CITY OF ALBUQUERQUE

**RE: San Roque / La Serena
441 & 457 Coors Blvd NW
Grading & Drainage Plan and Drainage Report
Engineer's Stamp Date: 06/10/21
Hydrology File: J10D049**

Based upon the information provided in your submittal received 06/10/2021, the Grading & Drainage Plan and Drainage Report **are not** approved for Building Permit and action by the DRB on Preliminary Plat or Site Plan for Building Permit. The following comments need to be addressed for approval of the above referenced project:

Storm Drain Plan
c2.3

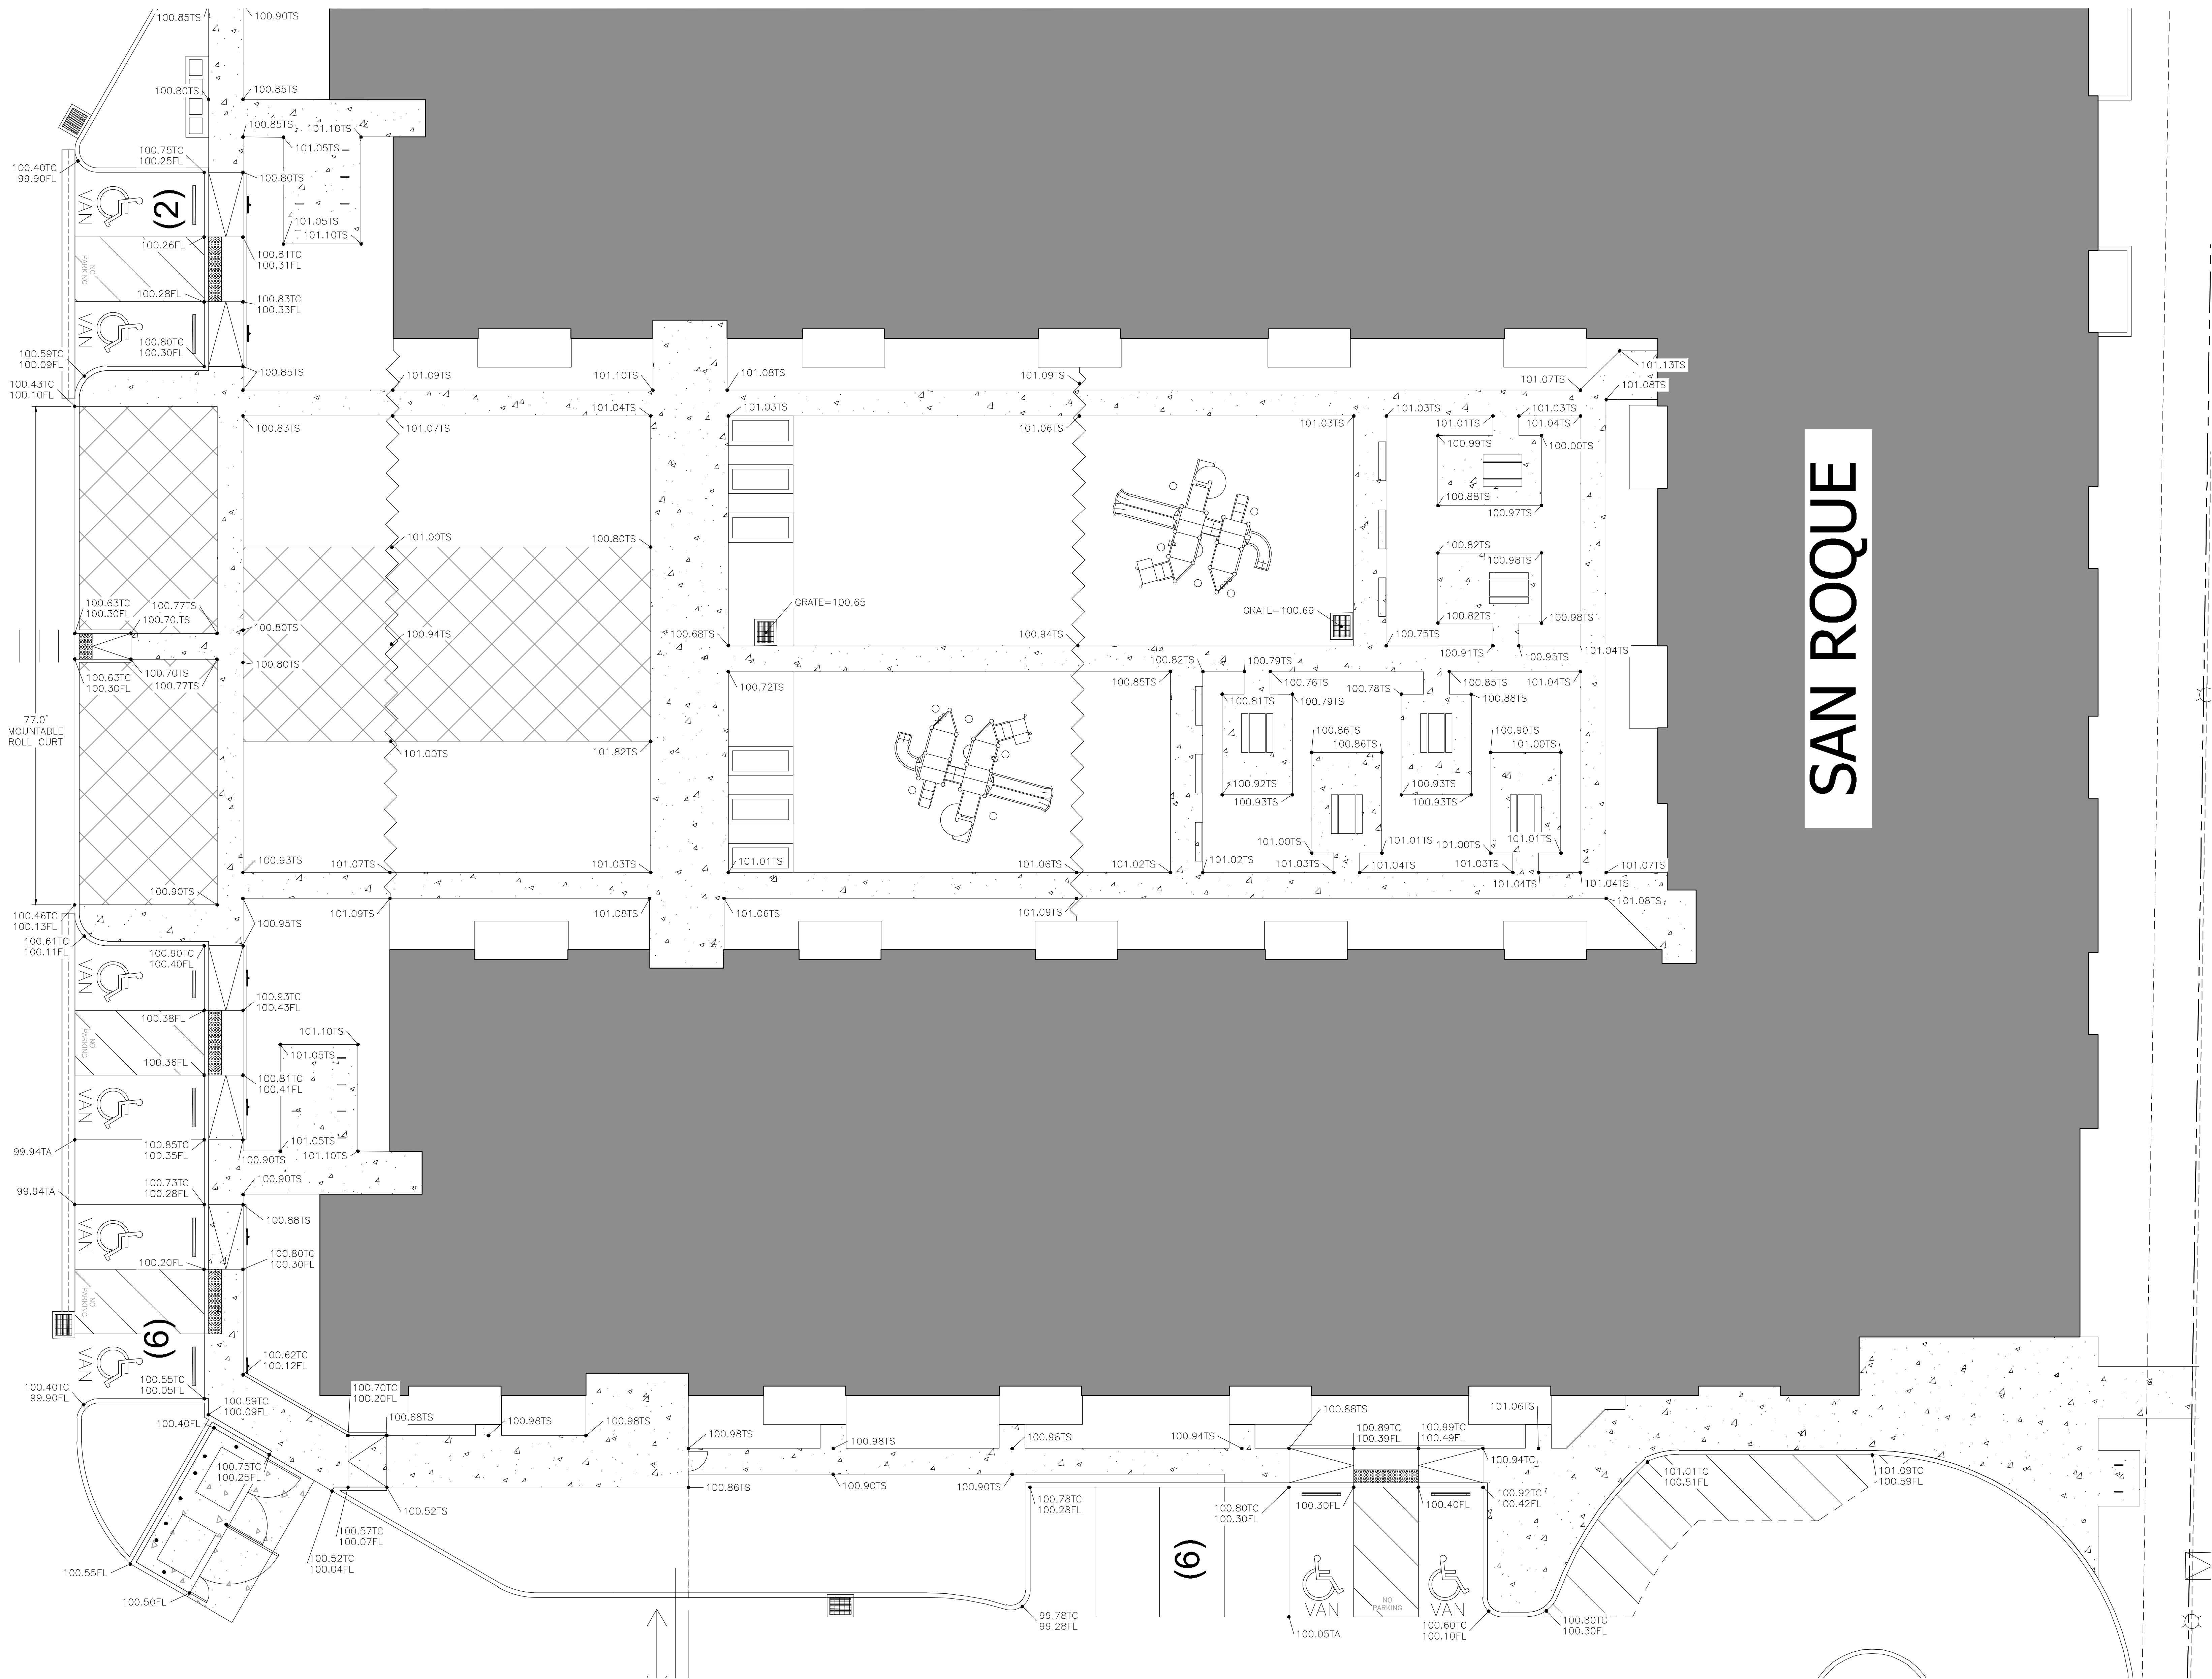
8. Sheet 2.3. Depending on the new design, this storm pipe layout may change.
9. Sheet 2.4, 2.5, & 2.6. Please change the title from “Grading Details” to “Grading Enlarged Area”. Also on Sheet 2.0, please show the these areas and label them to go to the correct sheet.
10. As a reminder, if the project total area of disturbance (including the staging area and any work within the adjacent Right-of-Way) is 1 acre or more, then an Erosion and Sediment Control (ESC) Plan and Owner’s certified Notice of Intent (NOI) is required to be submitted to the Stormwater Quality Engineer (Doug Hughes, PE, jhughes@cabq.gov , 924-3420) 14 days prior to any earth disturbance.
11. Standard review fee of \$300 (for DRB Site) will be required at the time of resubmittal.
